**YONKERS PUBLIC SCHOOLS
BUILDING RENOVATIONS AND
SITEWORK AT
SCHOOL 9**
53 FAIRVIEW STREET, YONKERS N.Y. 10703
S.E.D.# 69-25-00-01-0-009-009

ADDENDUM	NO.	DATE	BY
REVISION	1	1.4.2021	JMJ
ISSUED FOR BID		10.20.2020	
DRWN BY		JMJ	
CHECKED BY		JJE	
SHEET SIZE	ARCH E1 30" x 42"		
SCALE	AS NOTED

SHEET TITLE
THIRD FLOOR PLAN - NEW WORK

M-101

1 THIRD FLOOR PLAN - NEW WORK
SCALE: 1/8"=1'-0"

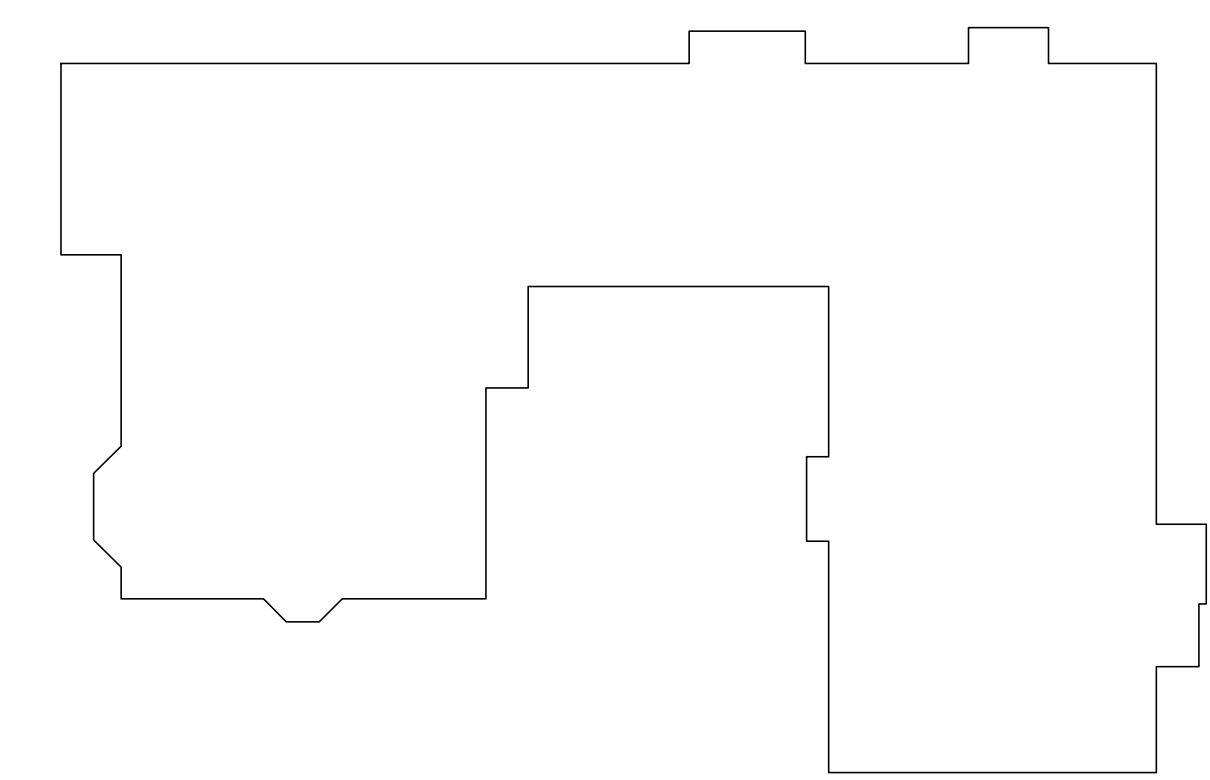
MECHANICAL CONTRACTOR TO ADJUST AAD-1 TO OUTSIDE AIR 200-2560 CFM. AAD AND AAD2 WILL BE ADJUSTED FOR 5000 CFM

NOTES:
1 - EXISTING EXHAUST FAN EF-5 TO REMAIN IN SAME LOCATION AND REUSE AAD-2 AND CONTROLS AS REQUIRED
